3B Containment Hydrodynamic Loads

The information in this appendix of the reference ABWR DCD, including all subsections, tables, and figures, is incorporated by reference with the following departures.

STD DEP 6.2-2 ([Table 3B-1, Figure 3B-13](#))

STD DEP Admin (Figures ~~3B-14~~, 3B-21, 3B-24, 3B-26)

Figure 3B-13 Schematic of the Pool Swell Phenomenon ~~Pool Boundary Pressure During Pool Swell, Normalized to Bubble Pressure~~

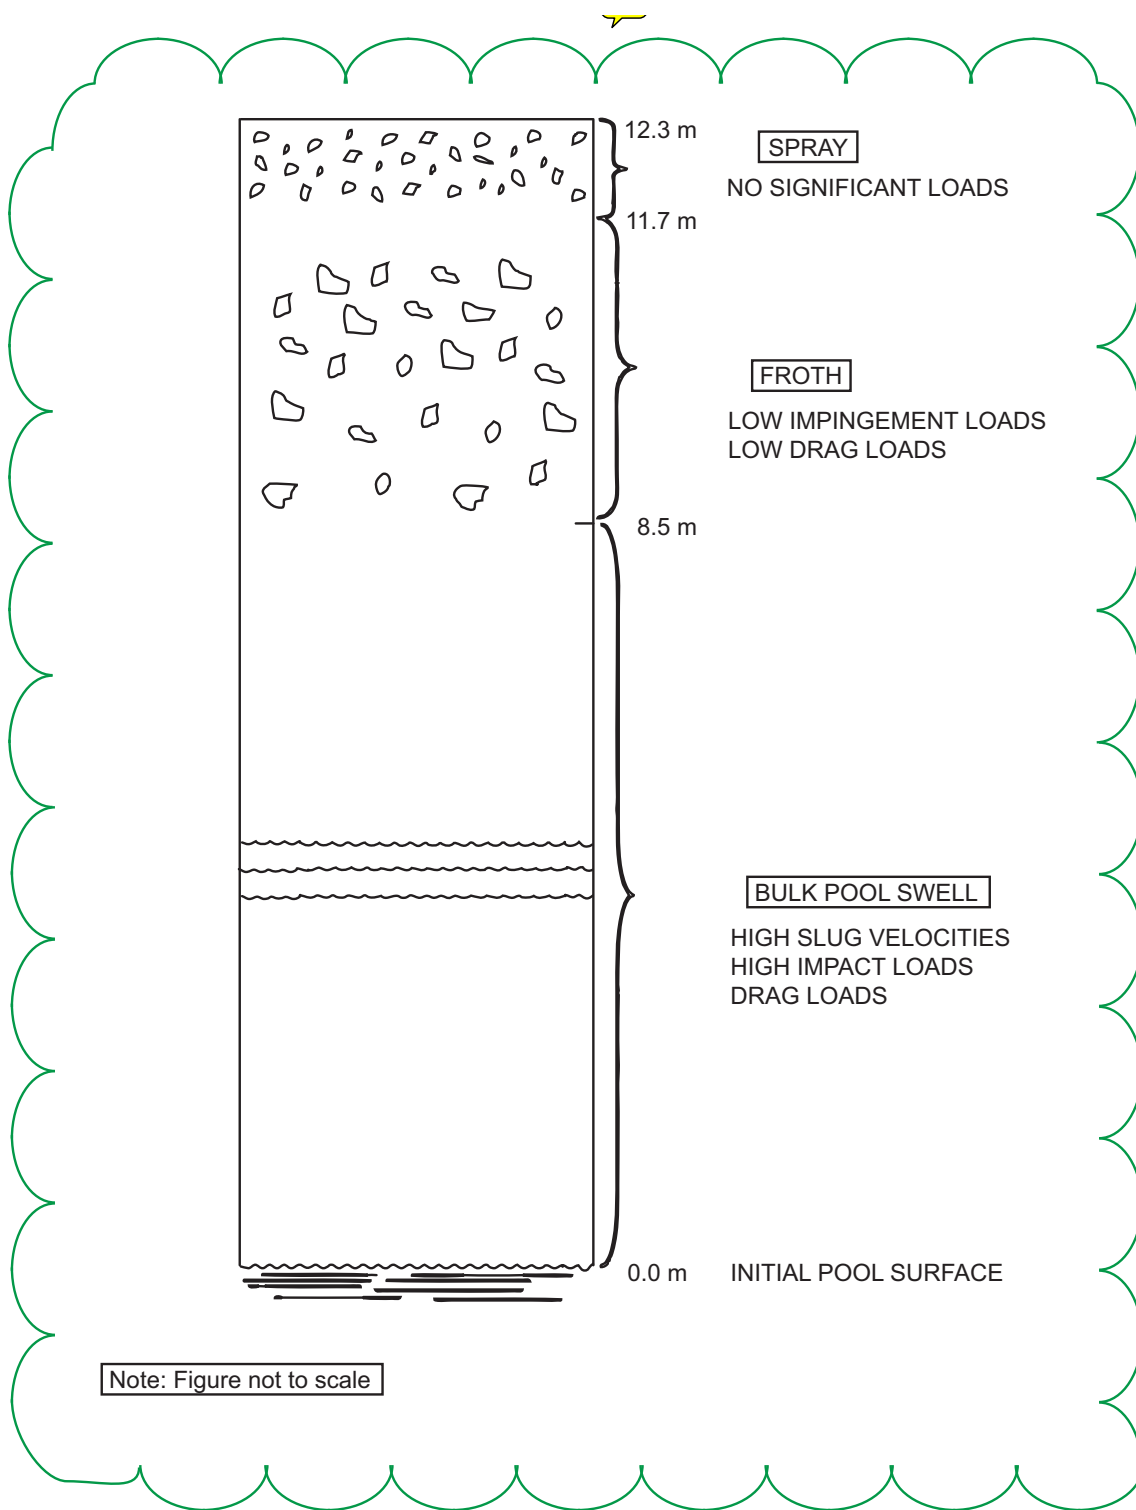
Structures located between 0 and ~~7m~~8.5m above the initial surface will be subjected to impact load by an intact water ligament, where the ~~7m~~8.5m value corresponds to the calculated maximum pool swell height. The load calculation methodology will be based on that approved for Mark II and Mark III containments (NUREG-0487 and NUREG-0978).

Structures located at elevations between the ~~7m~~8.5m and ~~10.3m~~11.7m will be subjected to froth impact loading. This is based on the assumption that bubble breakthrough (i.e., where the air bubbles penetrate the rising pool surface) occurs at ~~7m~~8.5m height, and the resulting froth swells to a height of 3.3m. ~~This froth swell height is the same as that defined for Mark III containment design and this.~~ This is considered to be conservative for the ABWR design. Because of substantially smaller wetwell gas space volume (about 1/5th of the Mark III design), the ABWR containment is expected to experience a froth swell height substantially lower than the Mark III design. The wetwell gas space is compressed by the rising liquid slug during pool swell, and the resulting increase in the wetwell gas space pressure will decelerate the liquid slug before the bubble break-through process begins. The load calculation methodology will be based on that approved for the Mark III containment (NUREG-0978).

As shown in Figure 3B-13 the gas space above the ~~10.3 m~~ 11.7m elevation will be exposed to spray condition ~~including~~ which is expected to induce no significant loads on structures in that region.
